ADDENDUM NO. 01

DATE 06.19.2014

PROJECT VMDO Project No.1115, Renovation of Three Residence Halls
PC# 217-17565-001

ISSUES AND REVISIONS
NO. SUBMITTAL 1 ADDENDUM 1
DATE 06.19.14**M601**

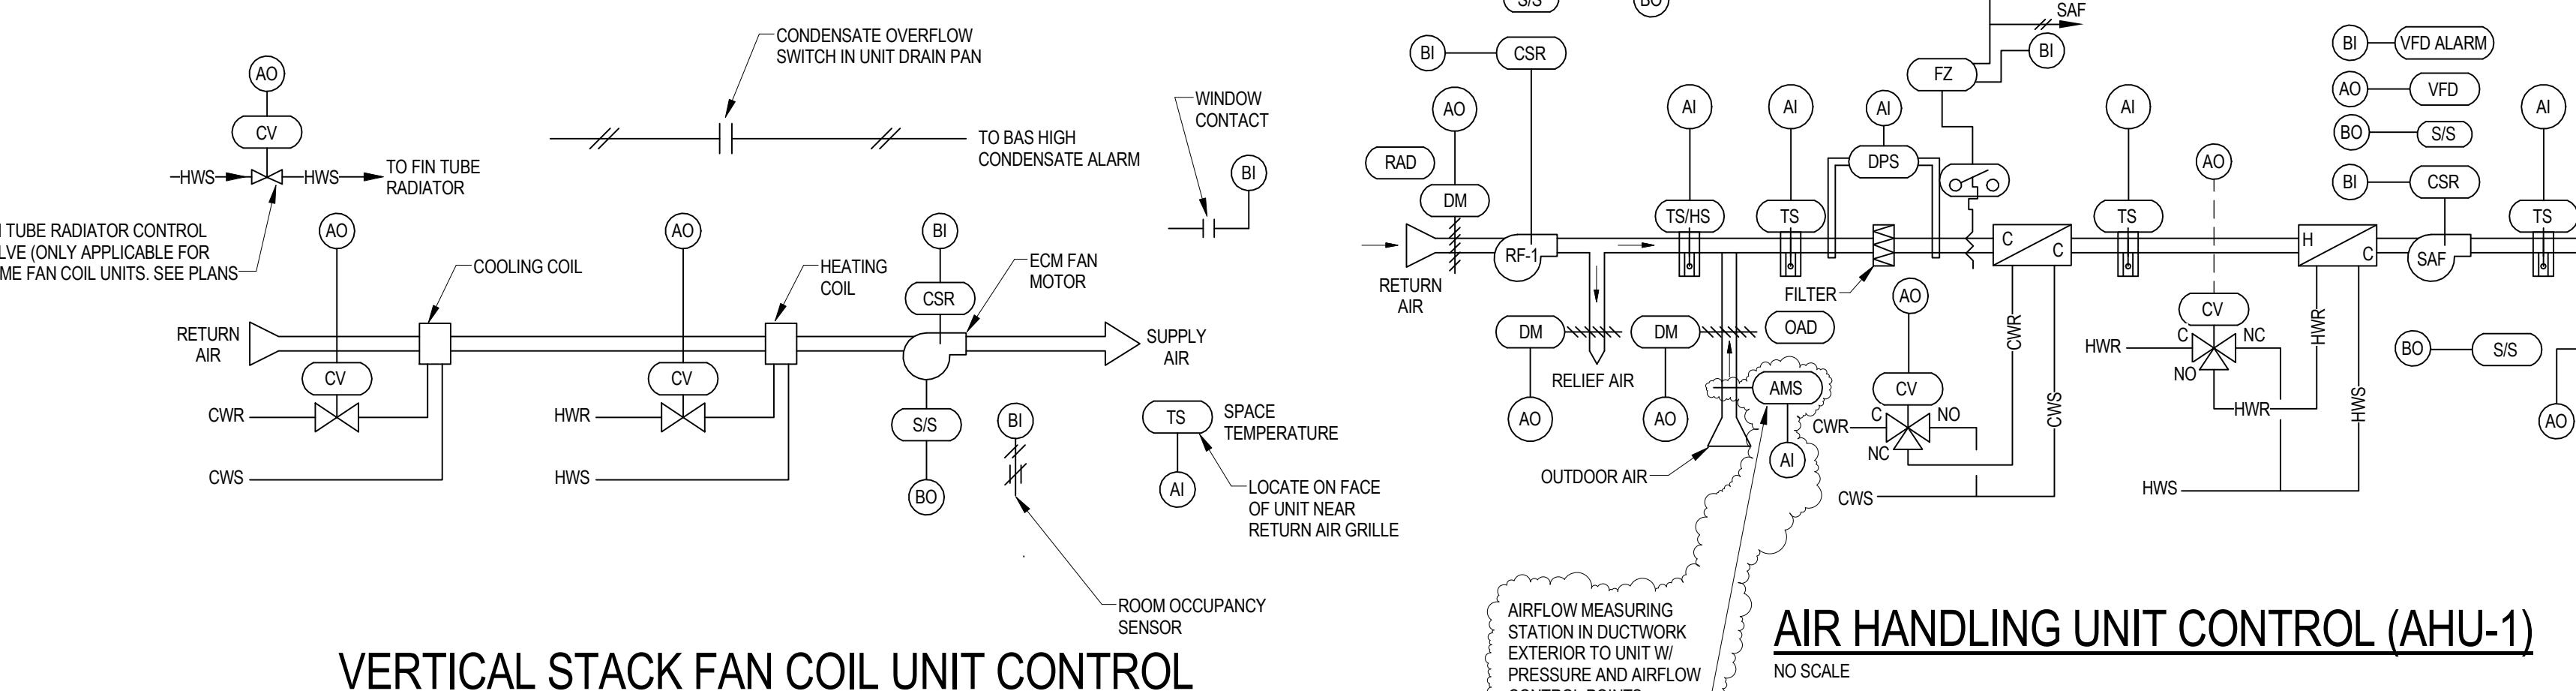
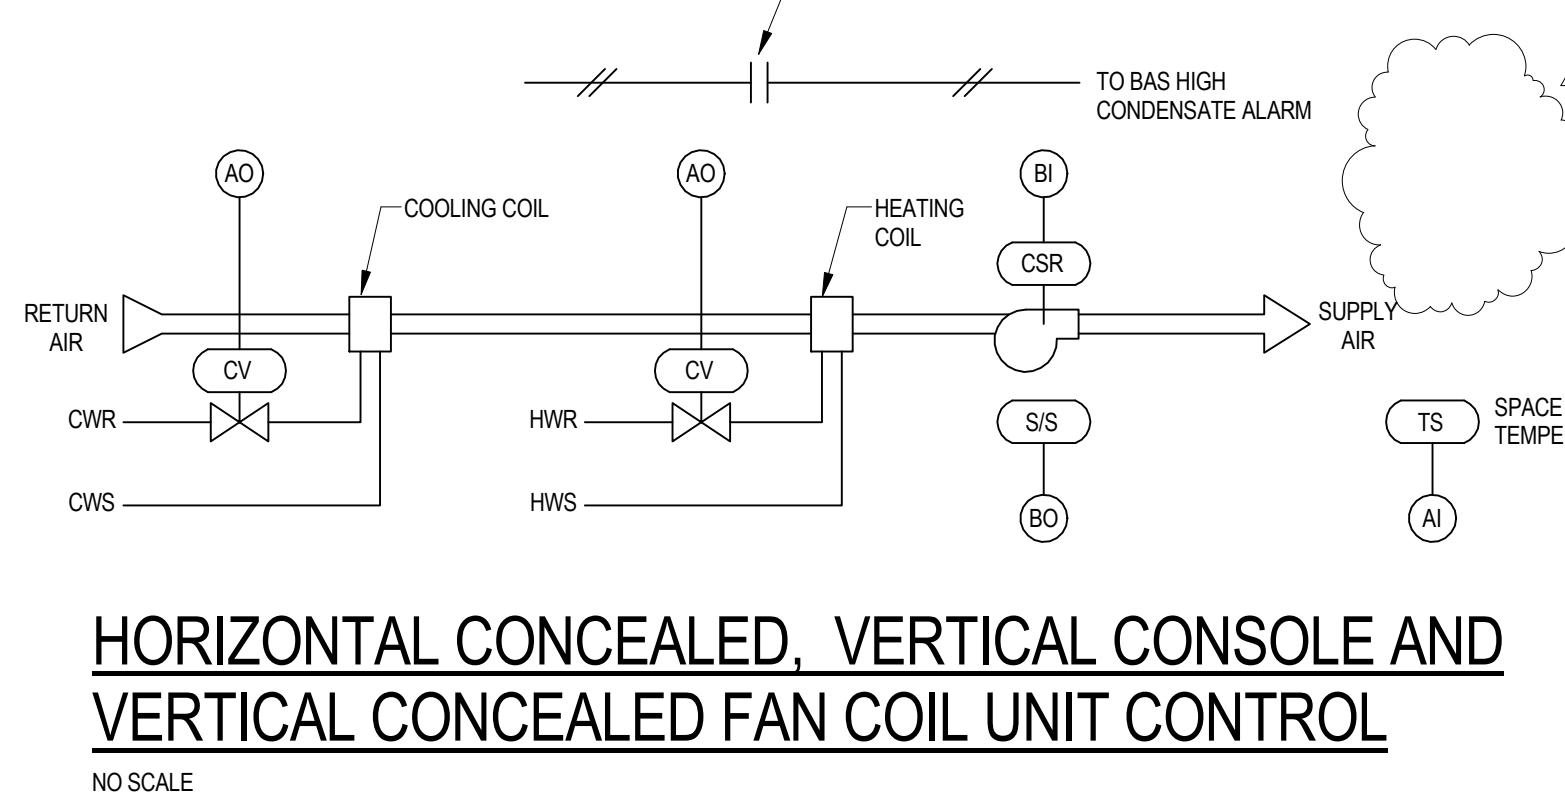
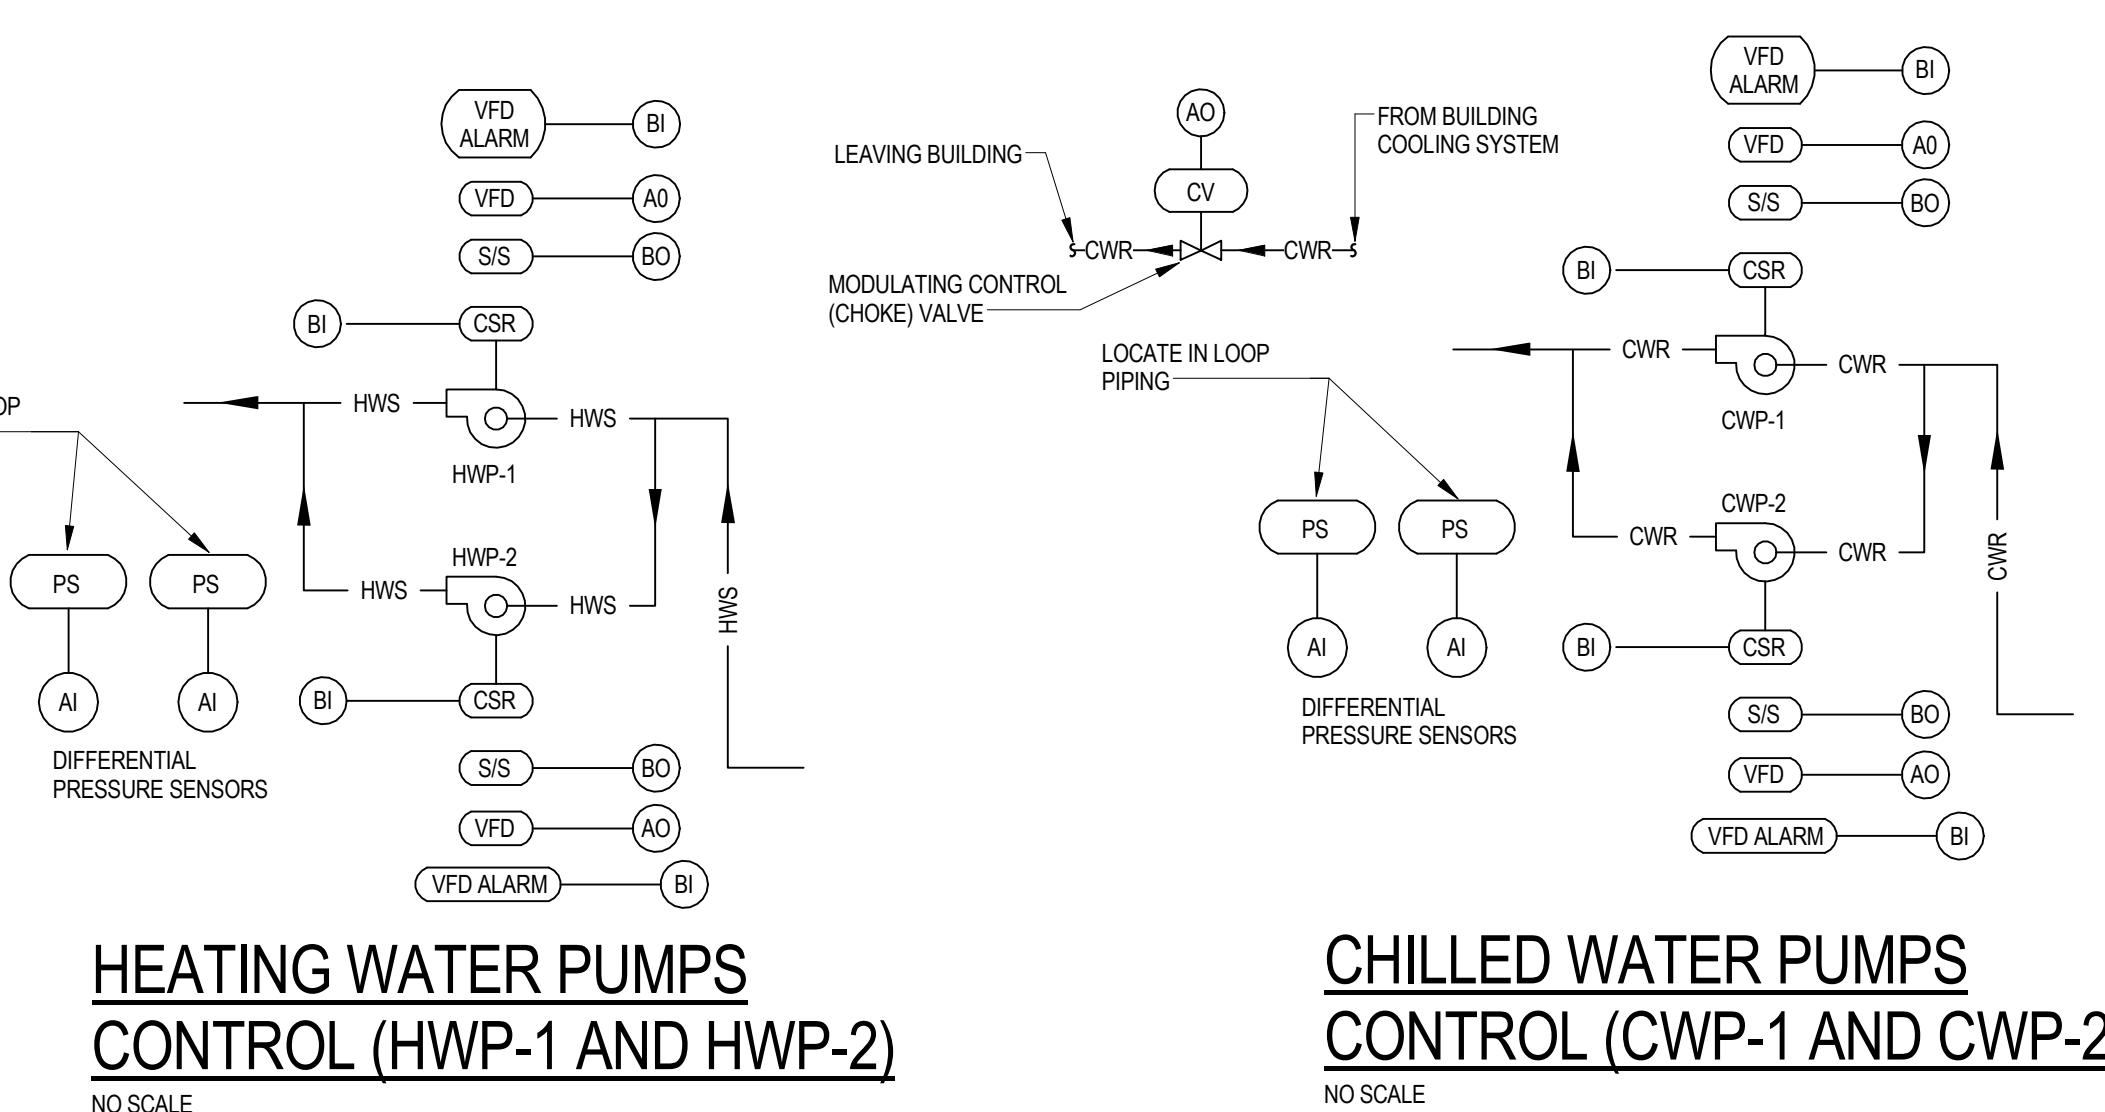
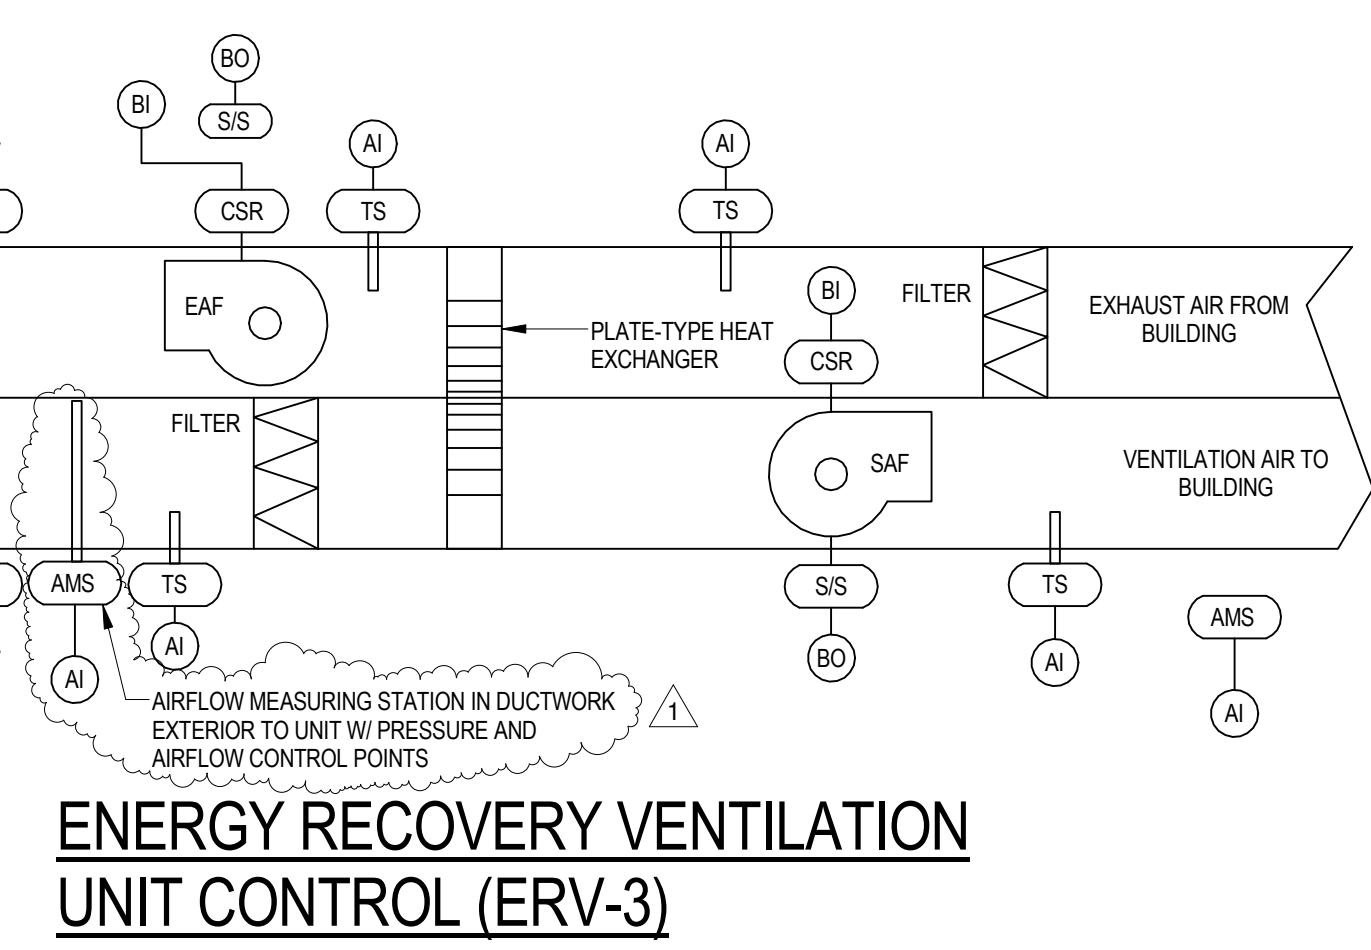
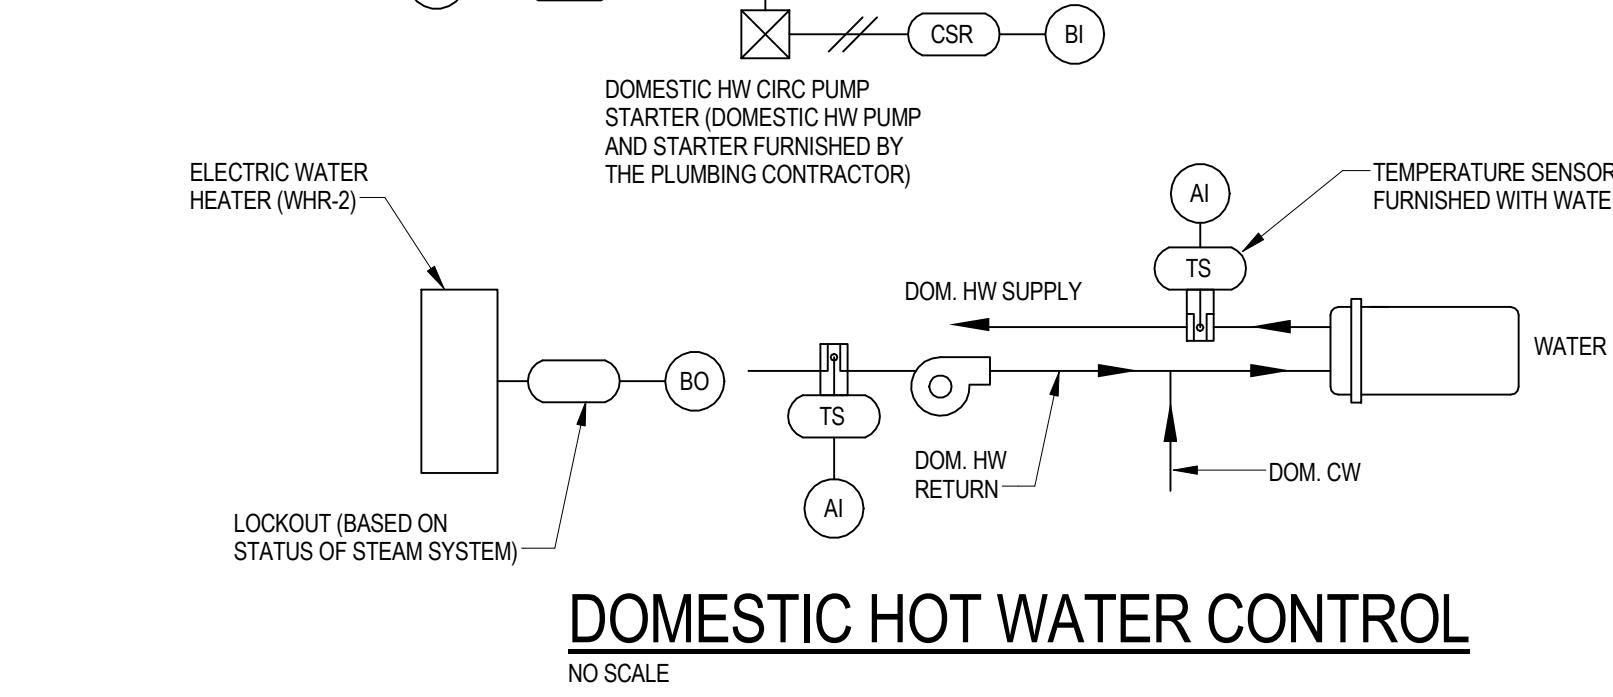
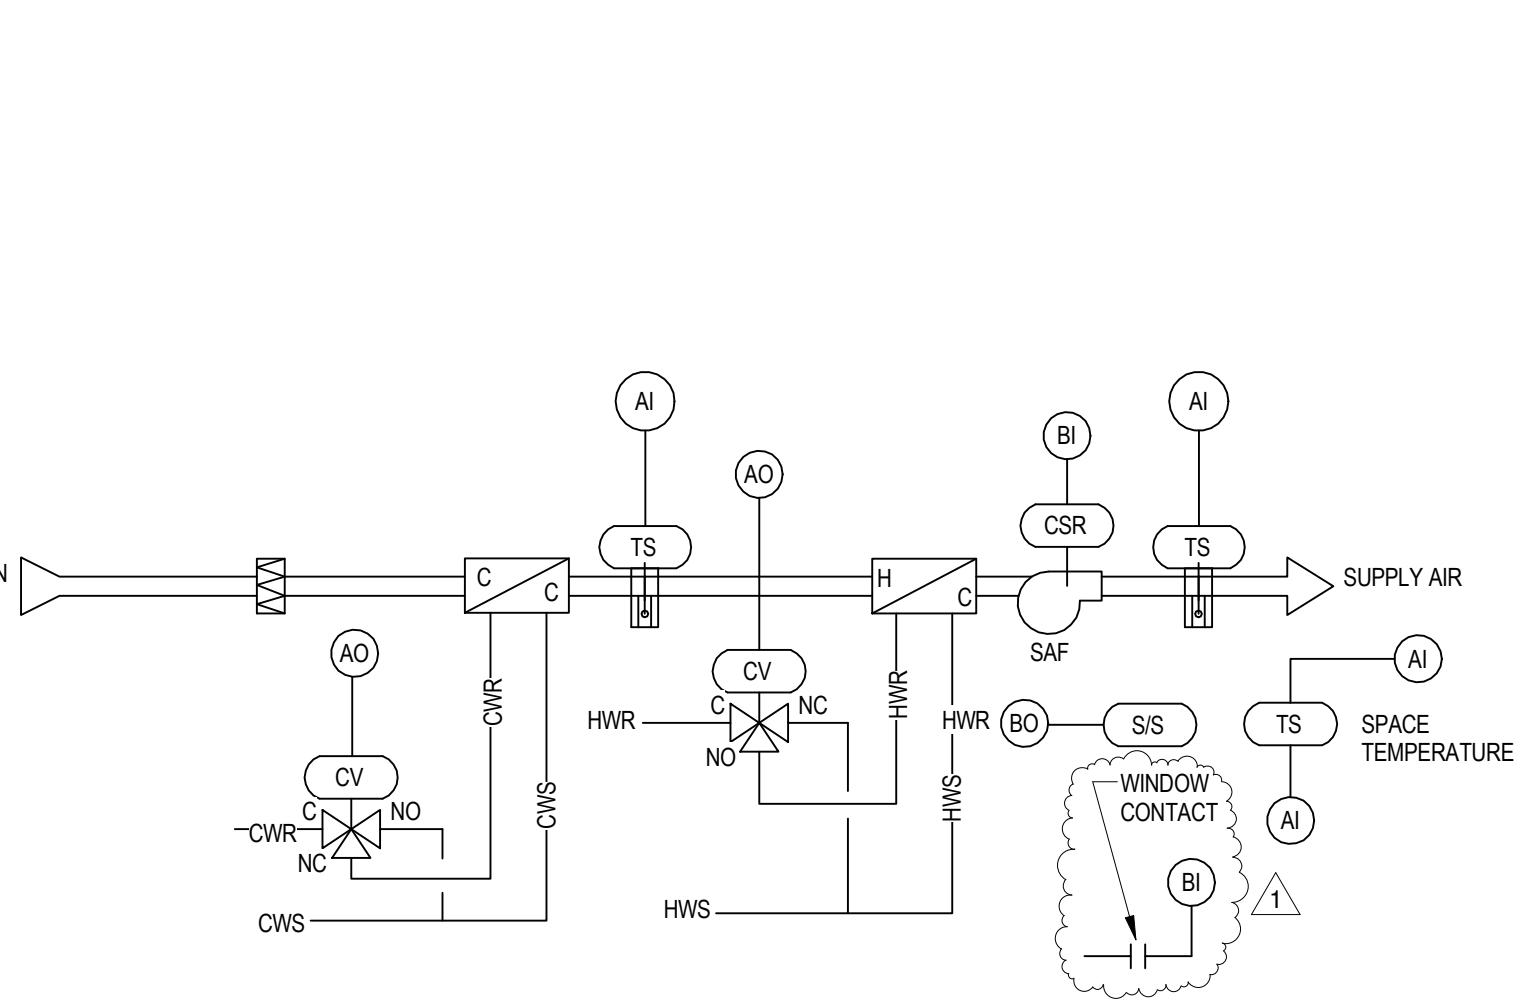
2.41 Remove window contact from horizontal fan coil unit control diagram.

2.42 Add airflow measuring stations to control diagrams for ERV-1/ERV-2, ERV-3 and AHU-1. Refer to attached revised drawing **M601**.

2.43 Revise combination humidistat/thermostat for EF-4 to be line voltage. Refer to attached revised drawing **M601**.

2.44 Revise cooling thermostat for EF-2 to be low voltage. Refer to attached revised drawing **M601**.

2.46 Add window contact to AHU-2/AHU-3 control diagram. Refer to attached revised drawing **M601**.

2.48 Add elevator shaft damper to miscellaneous control diagram. Refer to attached revised drawing **M601**.
